## ADDENDUM NO. 1

**DATE: August 23, 2016**

Contract 16-C-00021; Harbour Island Pumping Station Rehabilitation

W.O. 0000  
SHEET  
**E6**

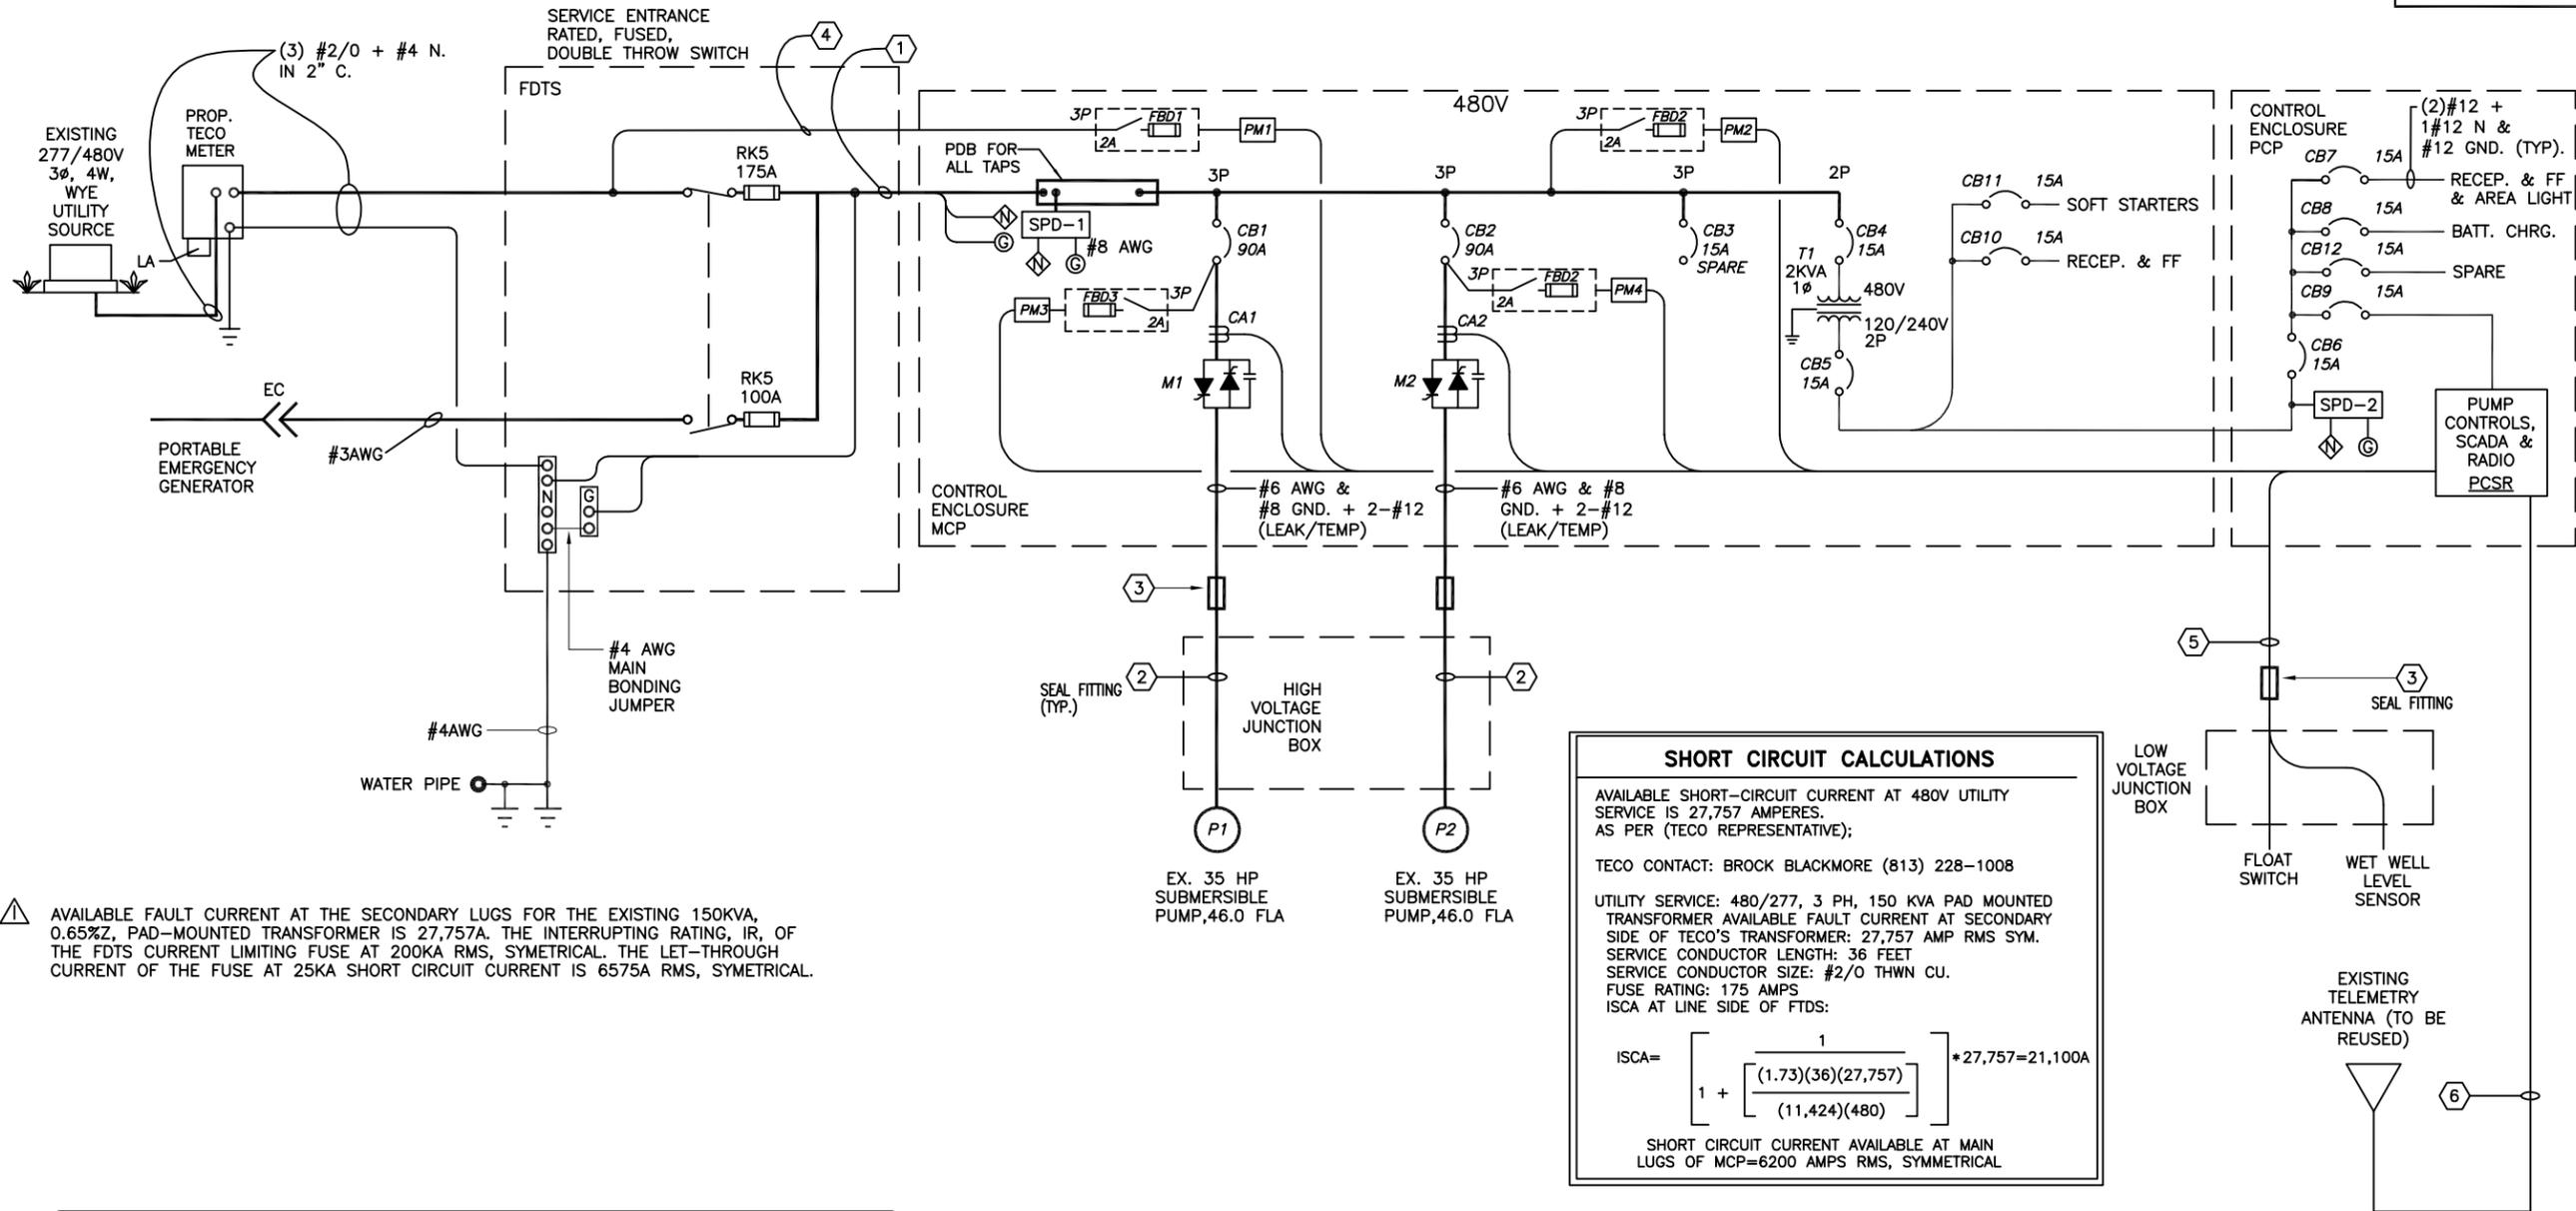
- Item 1: Replace Section 45 Electrical, with the attached Section 45 Electrical.
- Item 2: Page W46-10, subsection W-46.21, Add after 7 the following: 8. Current measurement range— 0 to 100A, 0 to 150A, and 0 to 200A; jumper selectable.
- Item 3: Replace plan sheet nos. EG3, E6, E9, E12 and E18 with the attached plan sheet nos. EG3, E6, E9, E12 and E18.
- Item 4: Attached for reference is the pre-bid meeting sign-in sheet.

- ① PROVIDE AND INSTALL THREE (3) 6" X 6" X 9' REINFORCED SQUARE CONCRETE POSTS.
- △ ② PROVIDE AND INSTALL 1-5/8" X 1-5/8" 316 STAINLESS STEEL UNISTRUT WITH 316 STAINLESS STEEL HARDWARE. NOTE: INSTALL ALL BOLTS FOR UNISTRUT COMPLETELY THROUGH CONCRETE POSTS.

- △ ③ PROVIDE AND INSTALL HEAVY DUTY, DOUBLE THROW, FUSIBLE SWITCH, 3-POLE, 600 VAC, 200 AMP IN NEMA 4X TYPE ENCLOSURE, 600 VOLT, DUAL-ELEMENT, TIME-DELAY CLASS RK5 FUSES; SWITCH--EATON DT364FWK, DT200NK-NEUTRAL KIT, DS200GK-GROUND LUG KIT, DS46FK-"R" FUSE ADAPTER KIT.

- ④ PROVIDE AND INSTALL PUMP CONTROL CABINET. REFER TO DETAIL ON SHEET E7.
- ⑤ PROVIDE AND INSTALL MOTOR CONTROL CABINET. REFER TO DETAIL ON SHEET E8.
- △ ⑥ PUMP MOTOR CONNECTIONS J.B.-USED AS A DEMARCATION BOX TO PROVIDE ISOLATION BETWEEN THE WET WELL AND PUMP CONTROLS. PROVIDE AND INSTALL A 12"x12"x6" NEMA 4X, STAINLESS STEEL JUNCTION BOX WITH HINGED DOOR, WIEGMANN #BN4121206CHSS. INSTALL A STAINLESS STEEL LOUVER PLATE KIT (4.75"x 4.5") ON SIDE OF BOX TO PROVIDE NATURAL ASPIRATION, WIEGMANN #WAVK0304SSA. TERMINATIONS SHALL BE MADE USING SPLIT BOLTS. CAREFULLY TAPE CONNECTIONS TO PROVIDE A 600V INSULATION LEVEL (TYPICAL FOR EACH CONDUCTOR) SEE SHEET E19 FOR JB DETAILS.

- ㉔ PROVIDE AND INSTALL (3)-#2/0 THWN CU + (1)-#4 THWN NEU. IN 2" CONDUIT.
- △ ㉕ INSTRUMENTATION AND CONTROLS J.B.-USED AS DEMARCATION BOX TO PROVIDE ISOLATION BETWEEN THE WET WELL AND PUMP CONTROLS. PROVIDE AND INSTALL A 12"x12"x6" NEMA 4X, STAINLESS STEEL JUNCTION BOX WITH HINGED DOOR, WIEGMANN #BN4121206CHSS. INSTALL A STAINLESS STEEL LOUVER PLATE KIT (4.75"x4.5") ON SIDE OF BOX TO PROVIDE NATURAL ASPIRATION, WIEGMANN #WAVK0304SSA. TERMINATIONS SHALL BE MADE WITH UNDERGROUND WIRE CONNECTORS - IDEAL MODEL #60 - (TYPICAL FOR EACH CONDUCTOR). SEE SHEET E19 FOR JB DETAILS.
